PLAN REVIEW SHEET

FIRST SUBMITTAL

CATS acknowledges receipt of the site plan and submits the following to the petitioner:

STD. NO.	REV.
60.02A

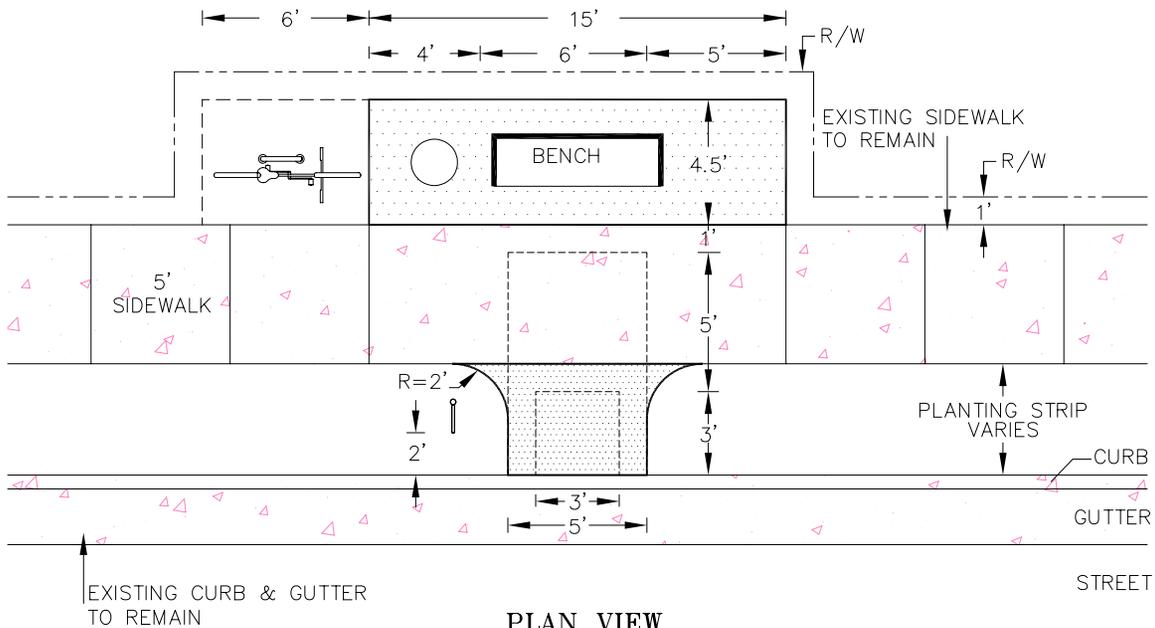
- 1) The petitioner's site is currently served on Statesville Avenue by Route 13 Nevin Road.
2) CATS requests the petitioner to preserve the existing sidewalk, waiting pad, bus shelter pad, bus shelter and bus stop currently located on Statesville Avenue (Transit Stop ID #30460).
3) CATS additionally requests the petitioner to construct a bench pad in Development Area 5 on Statesville Avenue, to be located approximately 60' South of the intersection of Statesville Avenue and Kohler Avenue, constructed to CATS Development Standards 60.02 A (see attached).

Please designate such in the site plan and/or accompanying notes. Please contact Leonard Ganther (CATS Operations) @ 704.432.1283 prior to demolition or construction, to coordinate any temporary relocation of the existing bus stop and bus shelter and to coordinate the final location of the new bench pad.
